SECTION 00 91 01

ADDENDUM NO. 1

BUILDINGS 5 & 6 RENOVATIONS
 San Mateo County Community College District

CAÑADA COLLEGE
 4200 Farm Hill Boulevard
 Redwood City, CA 94061

Date: 12/21/10, Drawing Number: AS NOTED, Project Number: 07013, E0.2

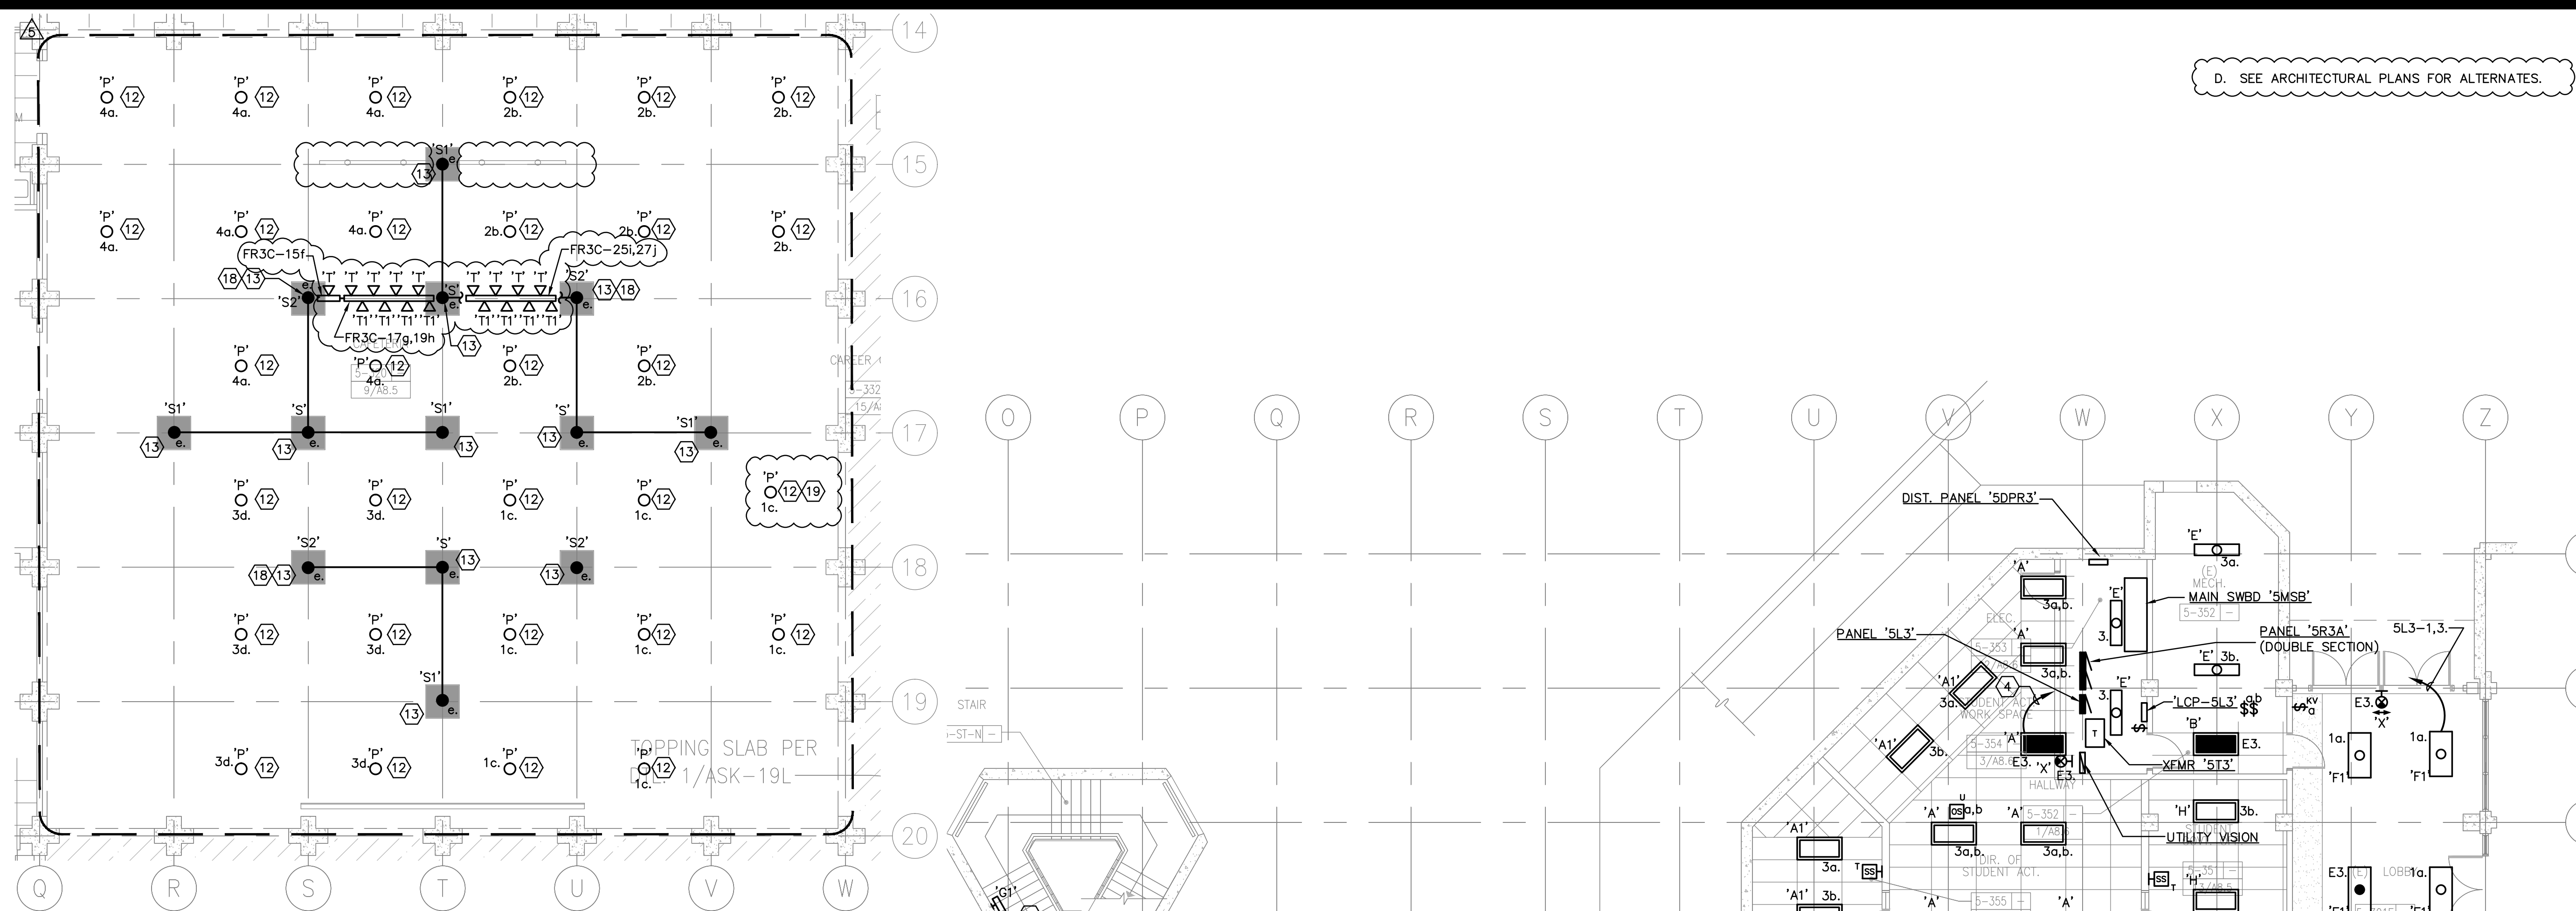
- A. Added General Sheet Note C, as shown on attached revised Drawing M2.3d.
12. E0.2 – Luminaire Schedule & Title 24 Calculations
 - A. Modified drawing as shown on attached revised Drawing E0.2:

1. Eliminated fixture type K
 2. Revised “Type T” Light Fixture information as shown in Luminaire Schedule on attached Drawing E0.2.
 3. Added “Type T1” Light Fixture information as shown in Luminaire Schedule on attached Drawing E0.2.

THIRD FLOOR PLAN
- LIGHTING

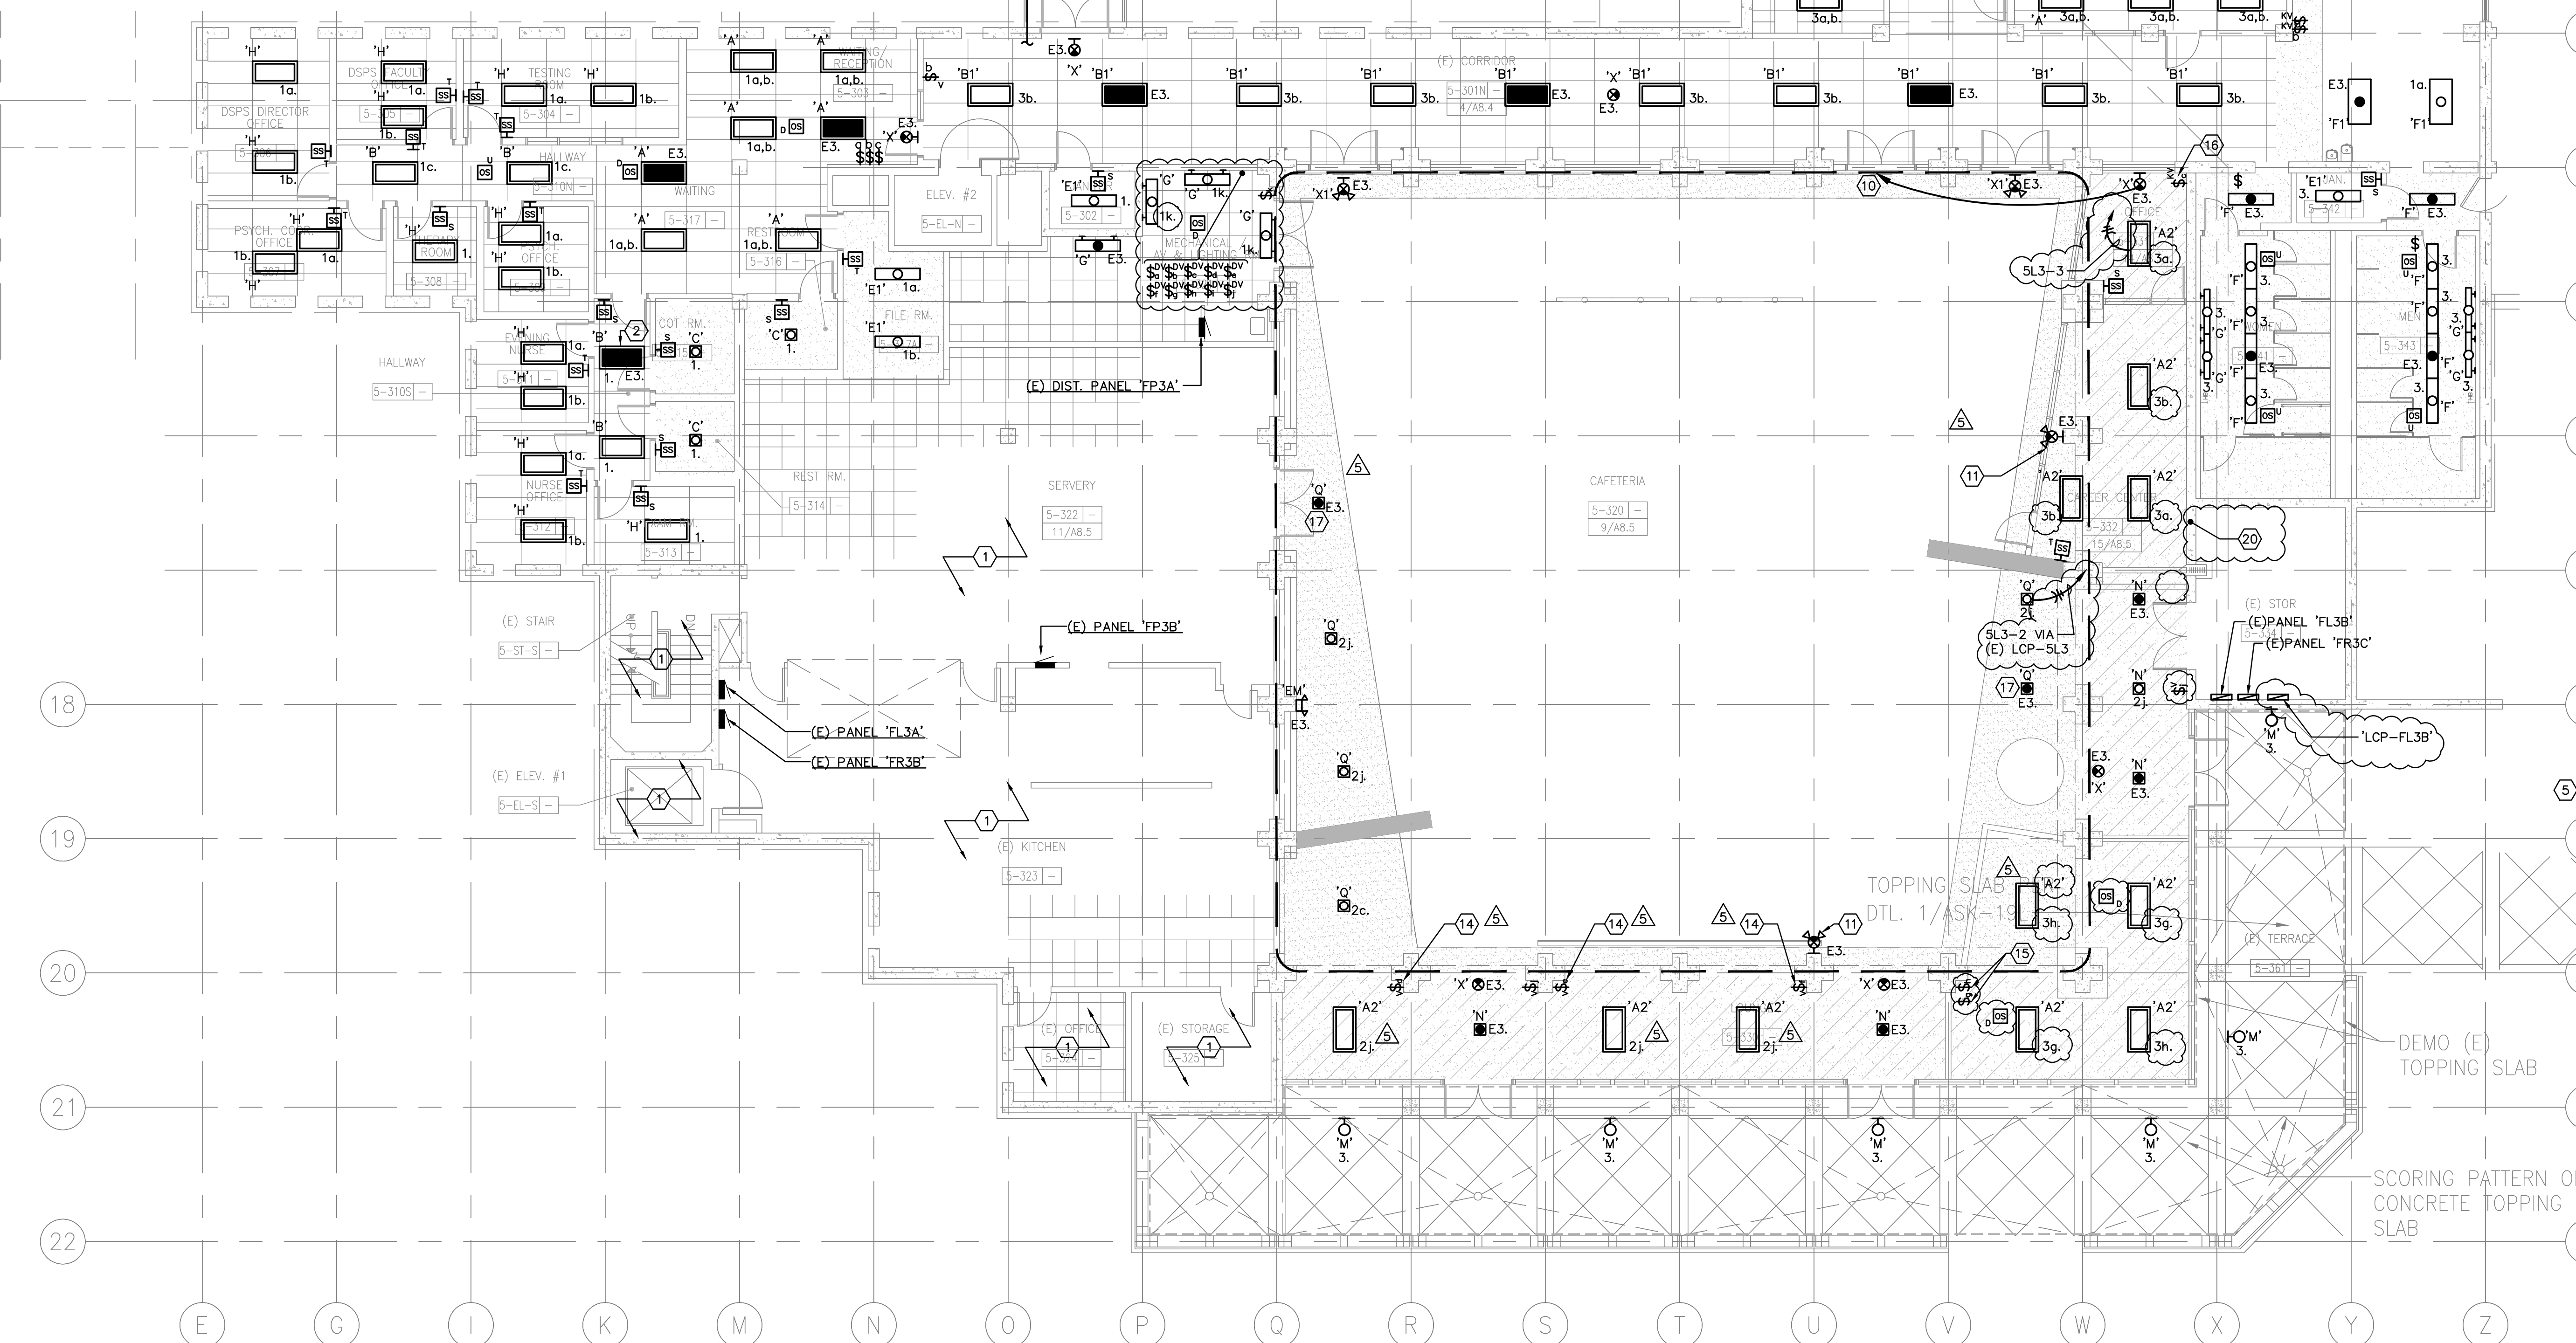
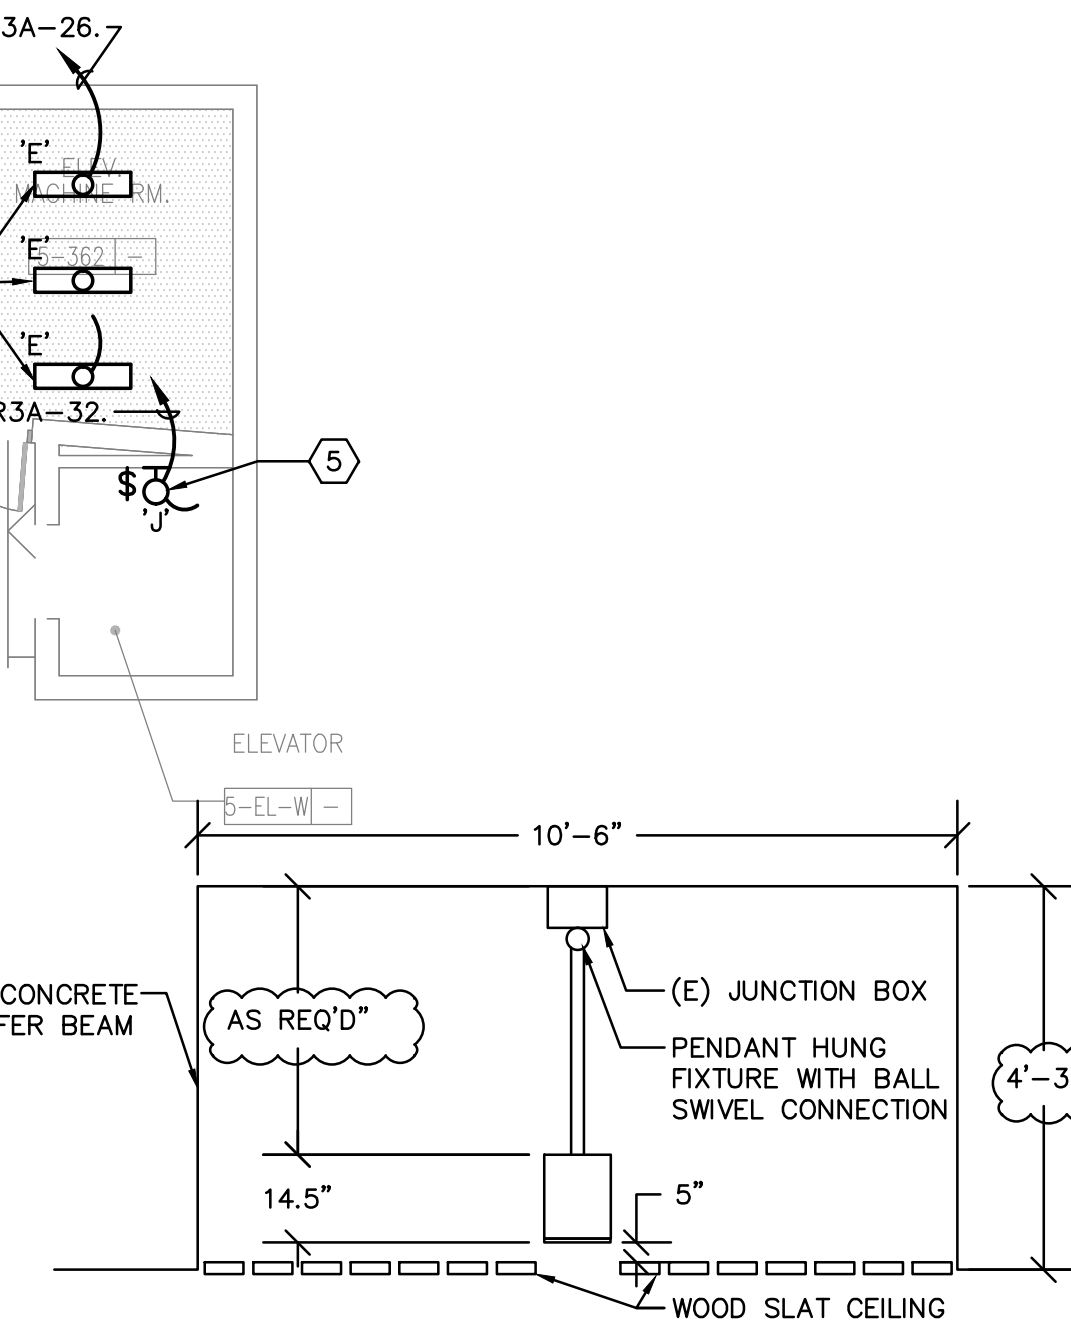
13. Drawing E2.3 – Third Floor Plan – Lighting.
 - A. Modified drawing as shown on attached revised Drawing E2.3:
 1. Revised location of type stage lighting (types T and T1).

2. Revised circuiting of stage track lighting (type T and T1).
 3. Added on type ‘P’ fixture as part of Add Alternate 8.
 4. Revised switching og type ‘G’ fixture in A/V Room.

5. Revised circuiting and switching in Student Lounge.
 6. Showed location of ‘LCP-FL3B’.
 7. Relocated switch ‘j’.
 8. Added General Sheet Note D.
 9. Added Lighting Control Panel in (E) Storage RM 5-334.

10. Revised Sheet Notes 12,13 and 15.

- 11. Added Sheet Notes 19 and 20.
 - 12. Relocated lighting control switches to North Wall of Mechanical / AV & Lighting Rm 5-321.
 - 13. Revised dimensions at Detail 3: Type P Mounting Detail.

- 14. Revise circuiting in Career Center
14. Drawing E3.3 – Third Floor Plan – Power
- A. Modified drawing E3.3 as shown on attached revised Drawing E3.3:

THIRD FLOOR PLAN - POWER

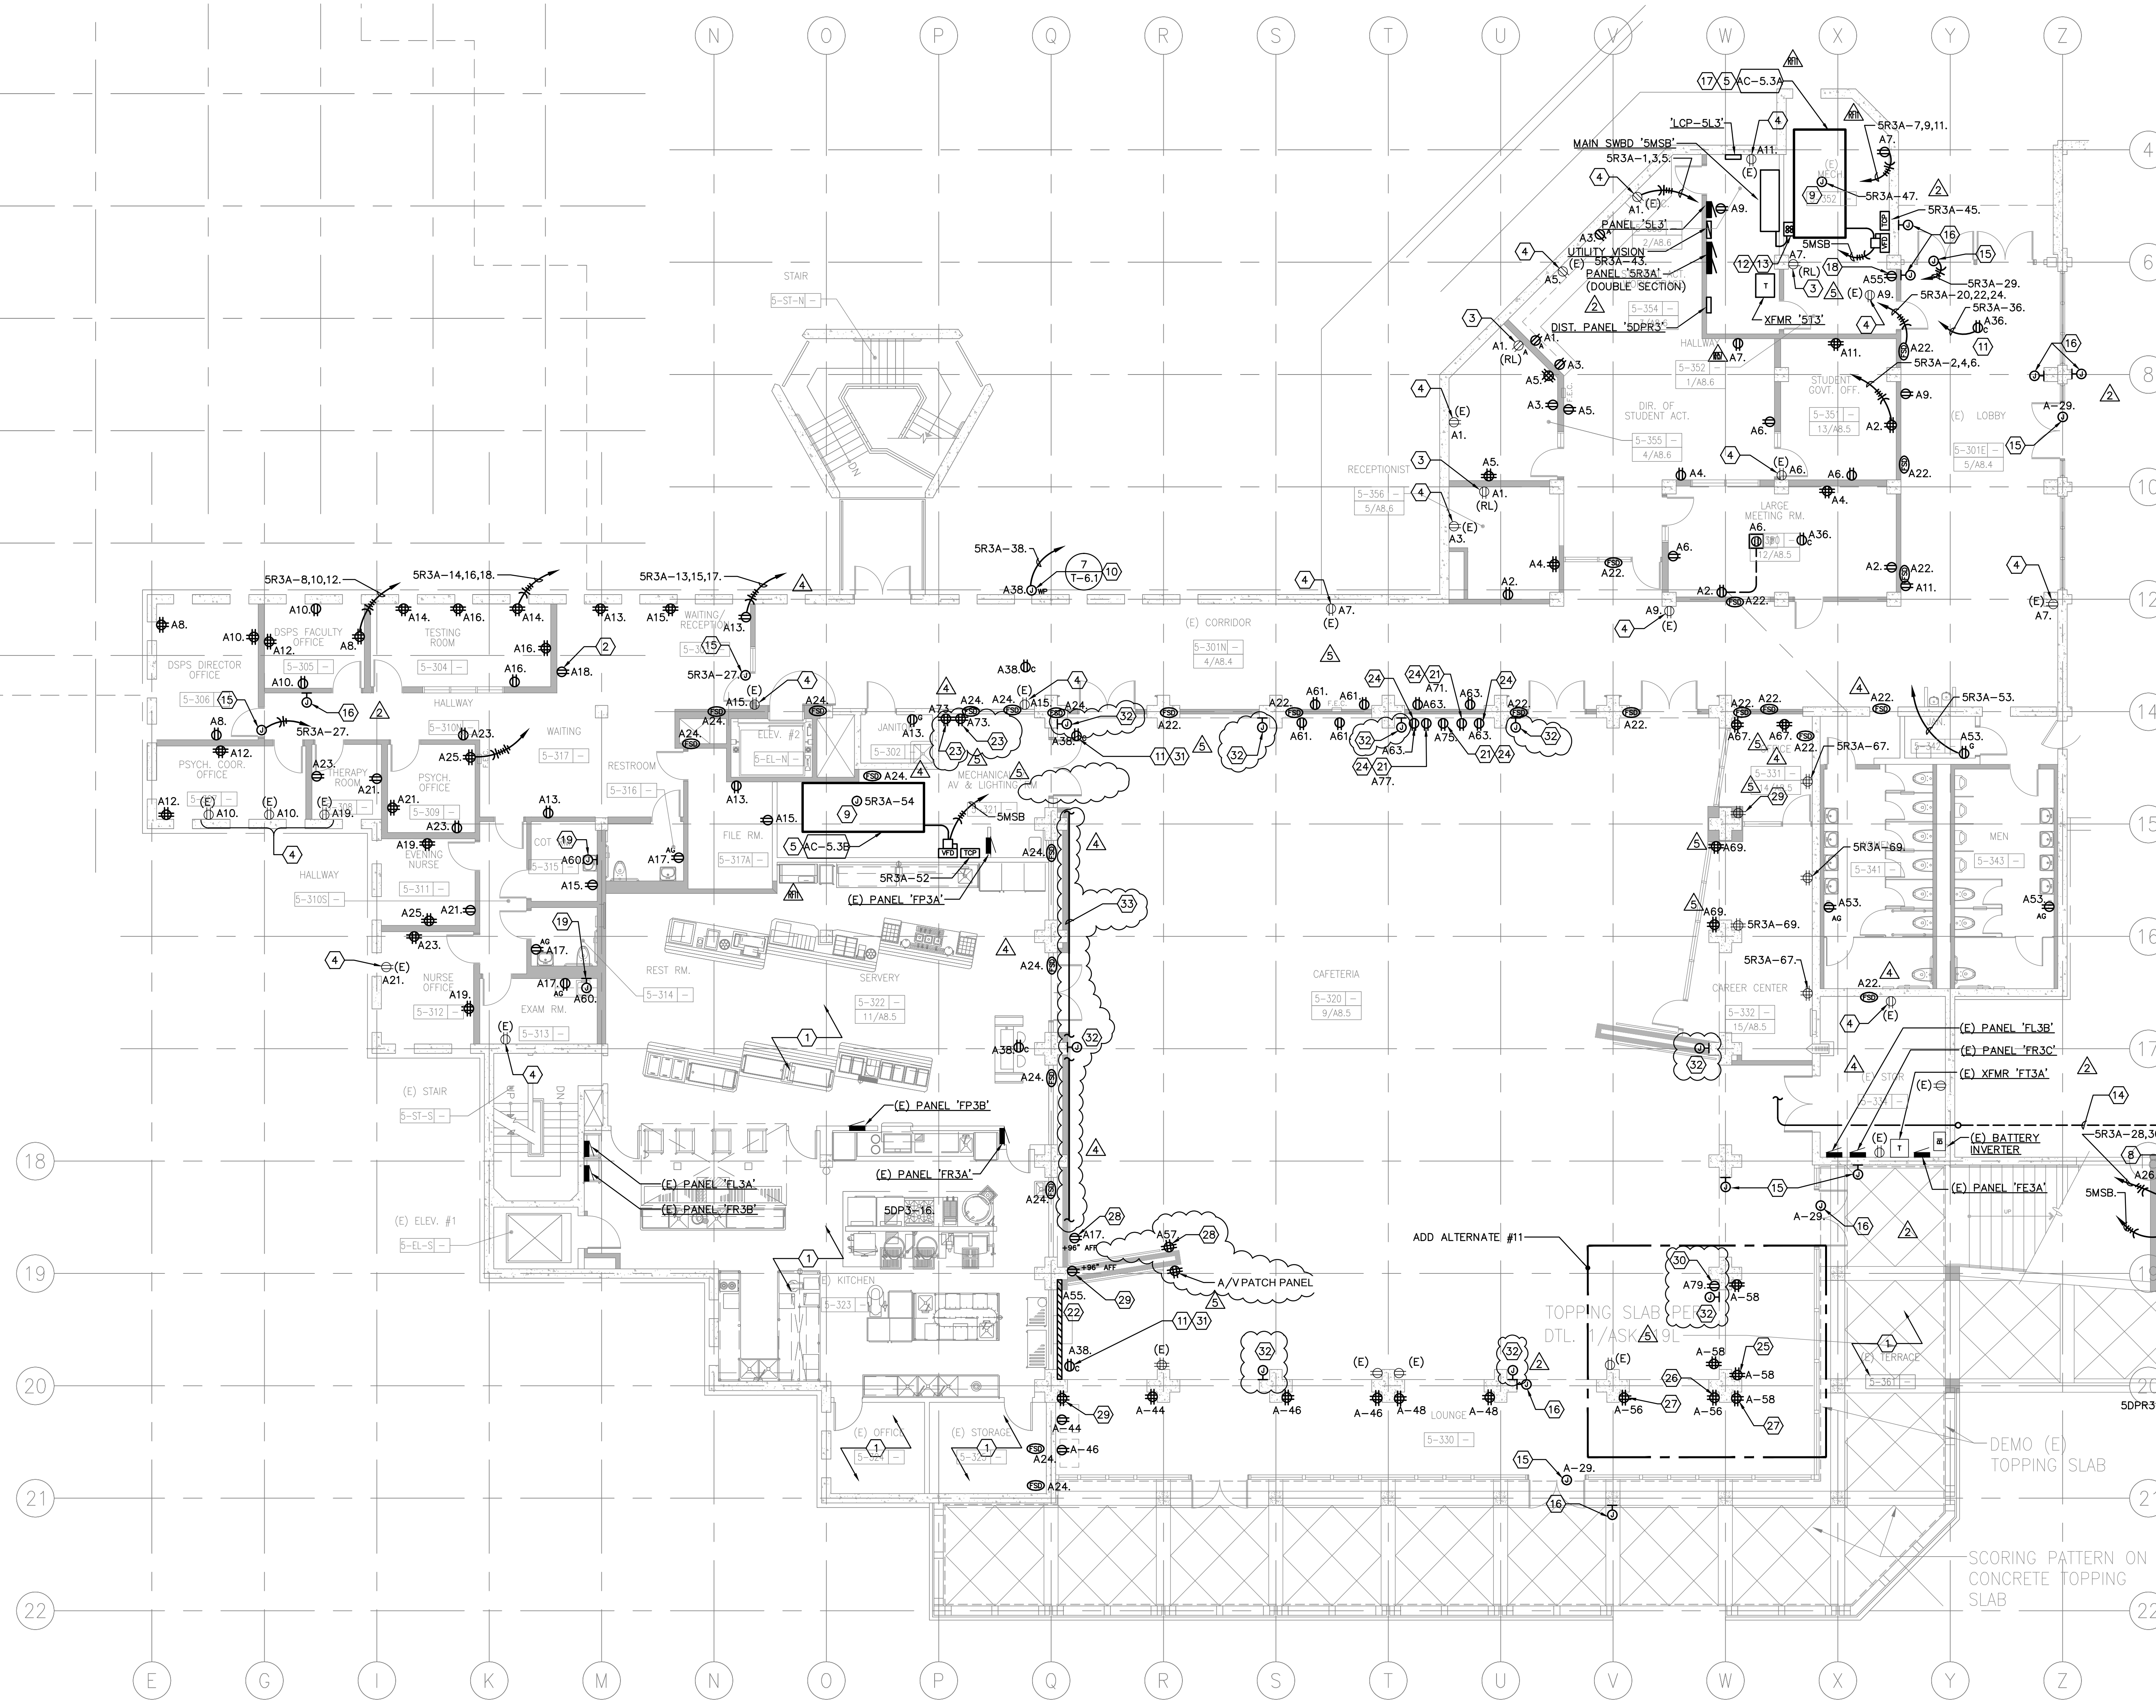
- 1. Revised Sheet Note 30.
 - 2. Added Sheet Notes 32 and 33.
 - 3. Revised location of quad receptacles for A/V rack in A/V room.
 - 4. Deleted power for track lighting lowering device in A/V room.

- 5. Added junction boxes for A/V speakers.
 - 6. Added power for sub-woofer.
 - 7. Added quad receptacle for second A/V controller.
 - 8. Added conduits for A/V cabling.

- 9. Substitute the words “A/V Patch Panel #2” for “A/V Patch Panel“ shown on drawing
15. Drawing T4.3 – Technology Third Floor.
- A. Modified drawing as shown on attached revised Drawing T4.3:
